CITY OF PITTSBURG
PITTSBURG/BAY POINT BART
MASTER PLAN
FINAL ENVIRONMENTAL IMPACT REPORT

SCH No. 2010122023

3.0 COMMENTS AND RESPONSES TO COMMENTS ON THE DRAFT EIR

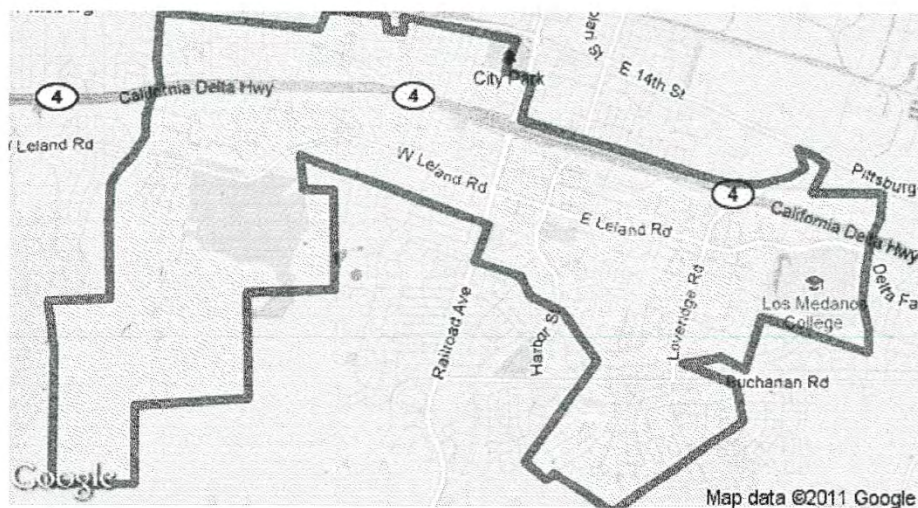
The Department of Toxic Substances Control (DTSC) understands you intend to conduct excavation work at the subject location. DTSC has determined the proposed excavation work is located within or in close proximity to the CAMP STONEMAN (J09CA0773 / CA99799F571400) Formerly Used Defense Site (FUDS) based, in part, on the United States Department of Defense ordnance maps located at http://www.envirostor.dtsc.ca.gov/regulators/deliverable_documents/5432401359/Camp%20Stoneman%20Maps.pdf. An approximate general location map is included with this document.

This FUDS site may contain abandoned munitions and explosives (collectively, ordnance) or other hazardous substances, which are considered hazardous materials as defined in section 25260 of the California Health and Safety Code. Significant impacts to human health and the environment may occur should workers encounter ordnance or other hazardous substances.

In order to protect human health and the environment, DTSC recommends measures be implemented to ensure hazardous materials are not encountered. If ordnance is discovered, DTSC recommends the following: 1) retreat from the area; 2) call 911 or local law enforcement; and 3) contact DTSC. If other hazardous materials are encountered, please contact your local environmental agency and DTSC.

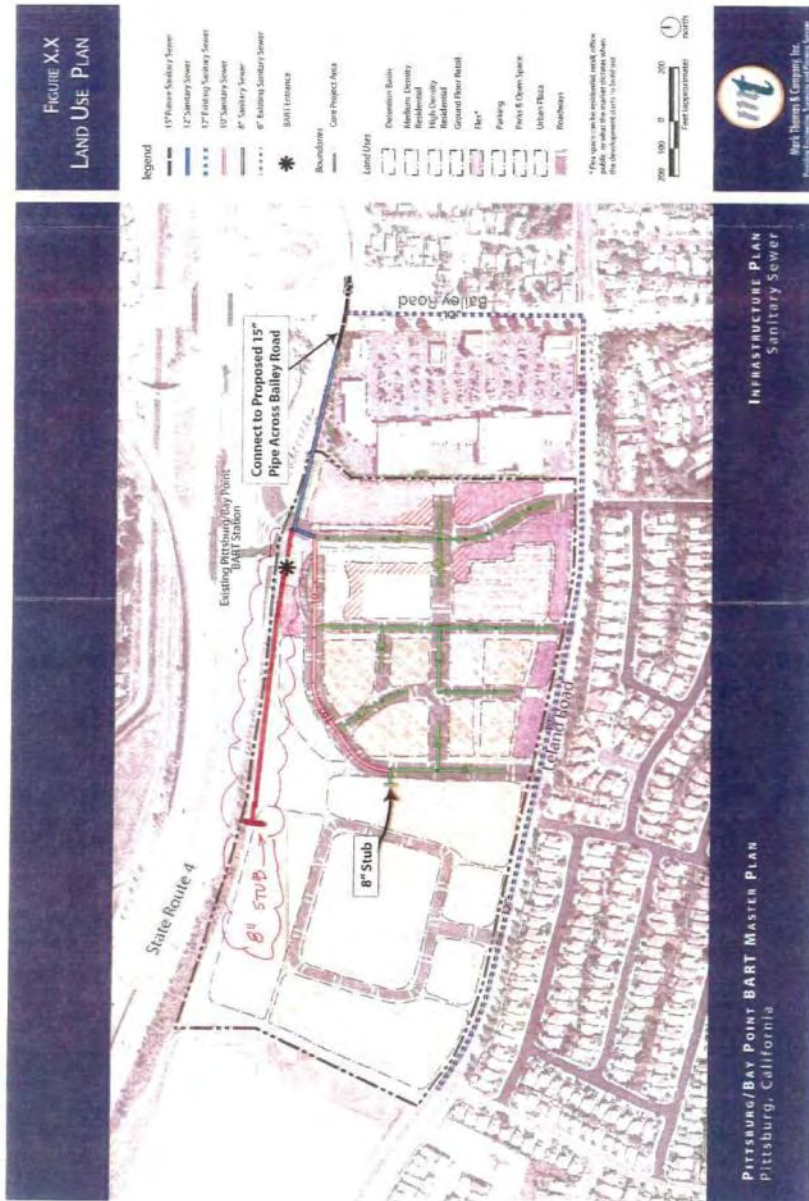
Figure XX – Land Use Plan: Since the West Coast Property naturally slopes toward the north, an additional 8" diameter sewer stub should be provided on the north side of the detention basin adjacent to State Route 4 as shown on the attached plan. This will avoid the need for very deep sewer piping draining upslope at adverse grades or sewer pumping systems when the Property is developed. | 5-32

Figure 3.0-4
Conceptual Site Plan

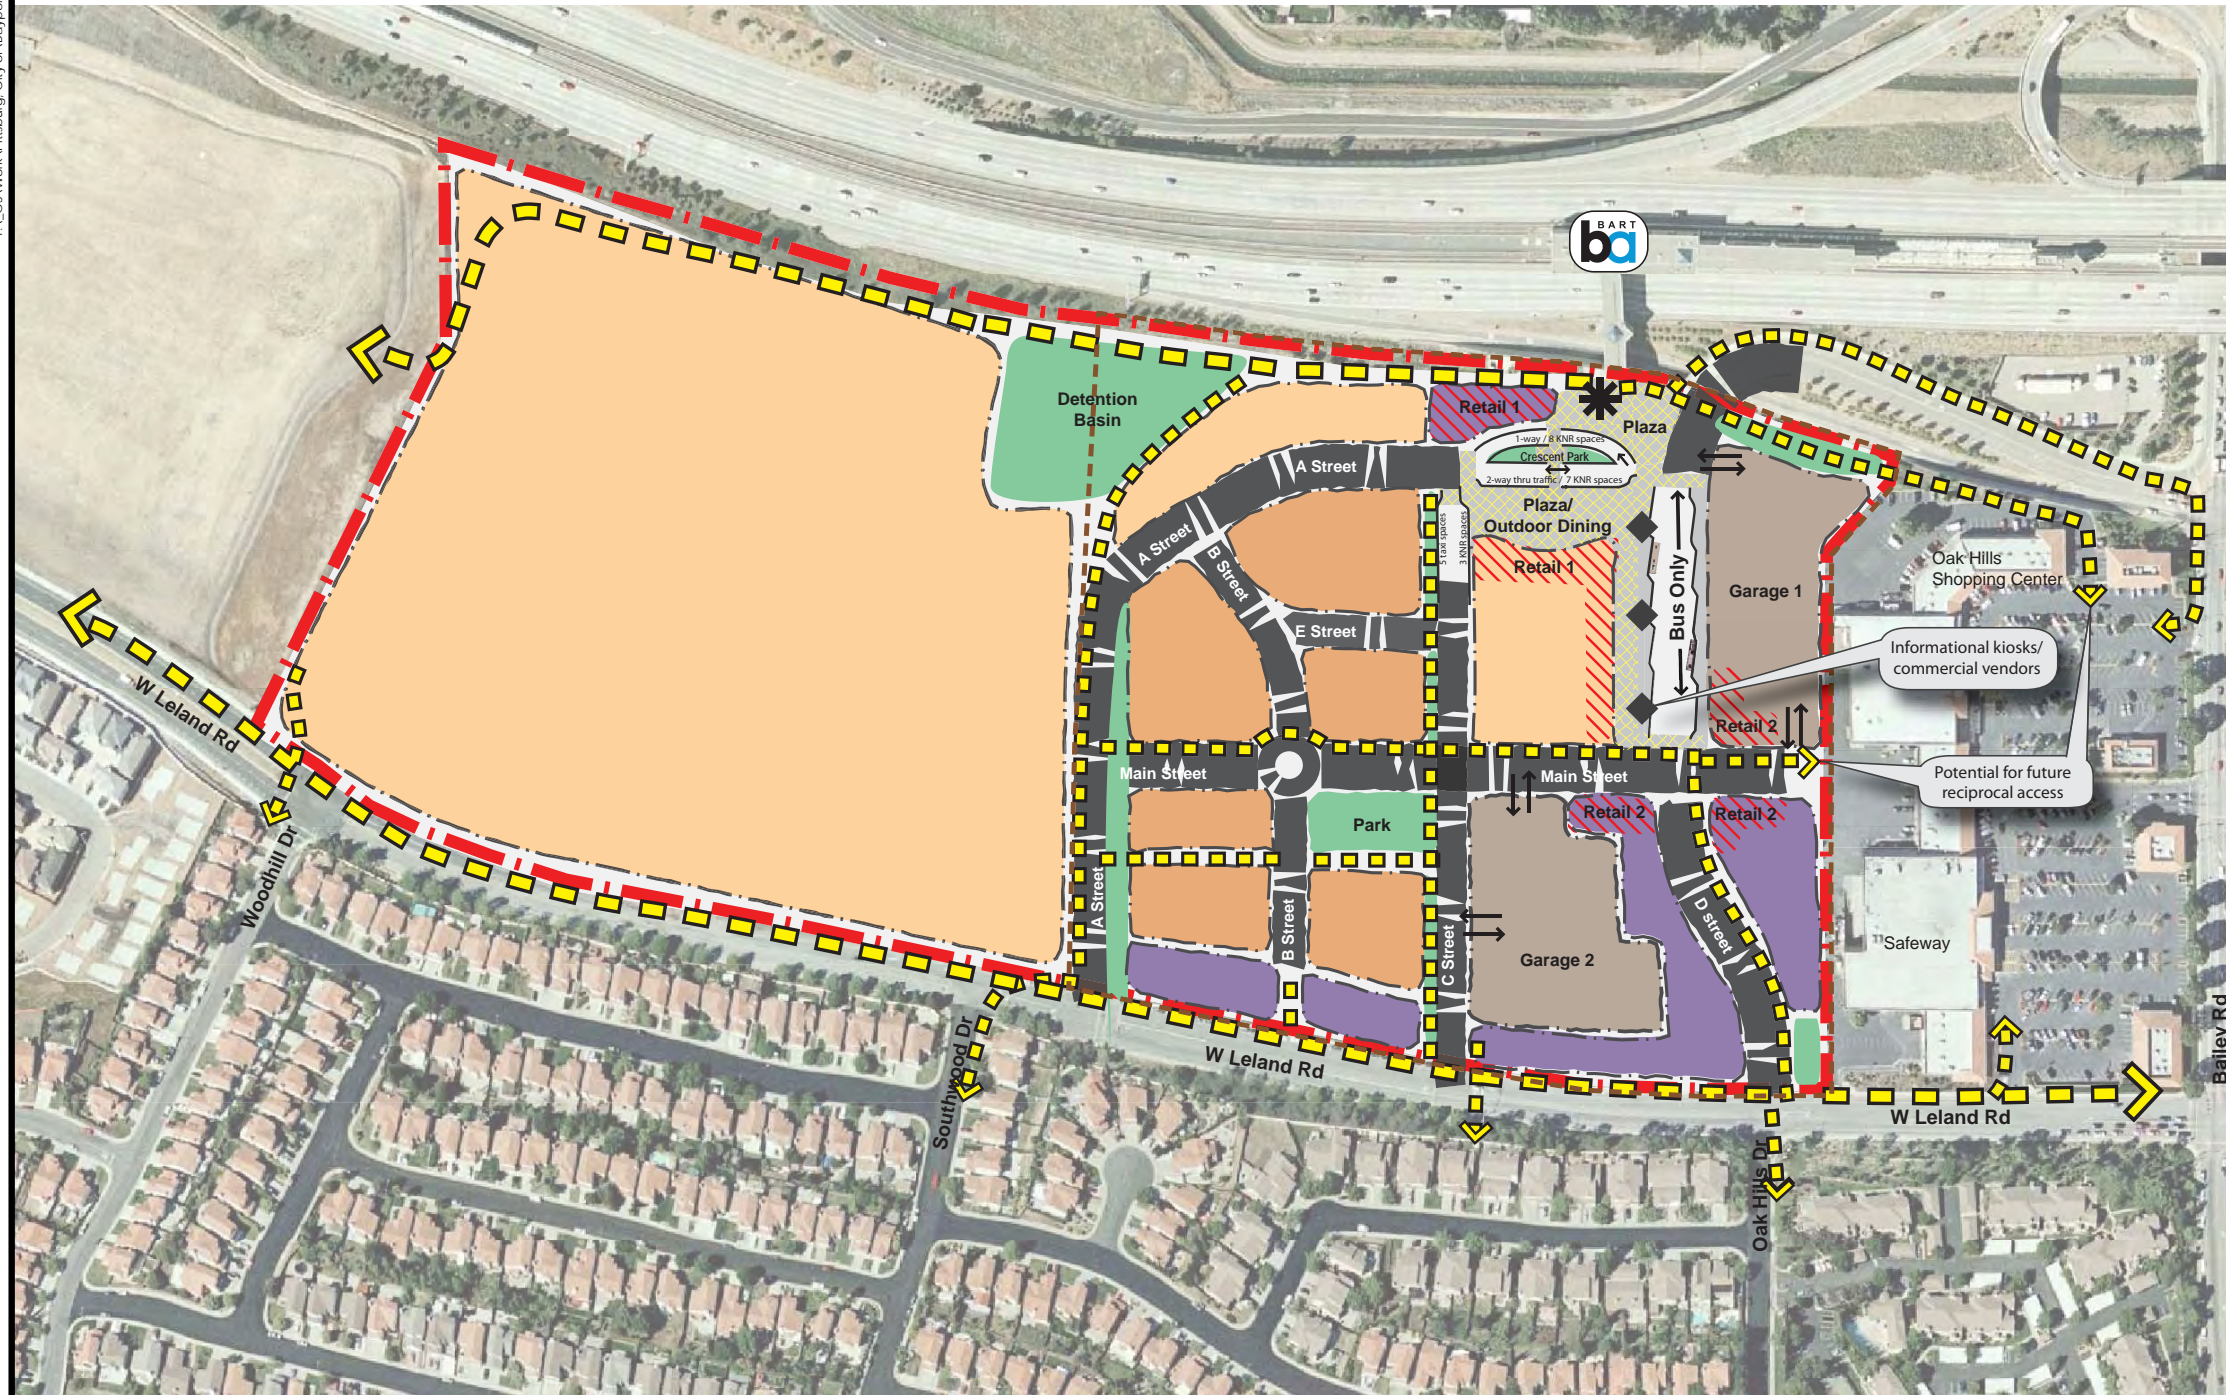
Page 3.0-15: Please acknowledge that Figure 3.0-4 has been modified to delete the landscaped strip along the west edge of the West Coast Site and revise the pedestrian/bicycle pathways and connections to the West Coast site.	5-16
Page 3.0-17: The pedestrian/bicycle pathway from the BART Station to the northern part of the Oak Hills Shopping Center is a potential improvement which may not be practical or feasible and should not be assumed to be constructed in Phase 1.	5-17
Figure 3.0-5: See page 3.0-17 comment above.	5-18
Page 4.0-2: Reference in the second paragraph should be to Table 4.0-2, not 3.0-2.	5-19
Page 4.4-59: See comments on MM 4.4.4 above.	5-20

Response 5-16: In reference to Page 3.0-15 of the Draft EIR, the commenter requests that the document acknowledge that Figure 3.0-4 has been modified to delete the landscaped strip along the west edge of the West Coast Site and revise the pedestrian/bicycle pathways and connections to the West Coast site.

Figure 4.1, Conceptual Land Plan, and all related figures in the Master Plan will be modified to eliminate the linear green space along the West Coast Home Builders western property line. Figure 3.0-4 of the EIR will be amended accordingly.

Figure 3.0-4 has been revised in DEIR Section 3.0, page 3.0-13:
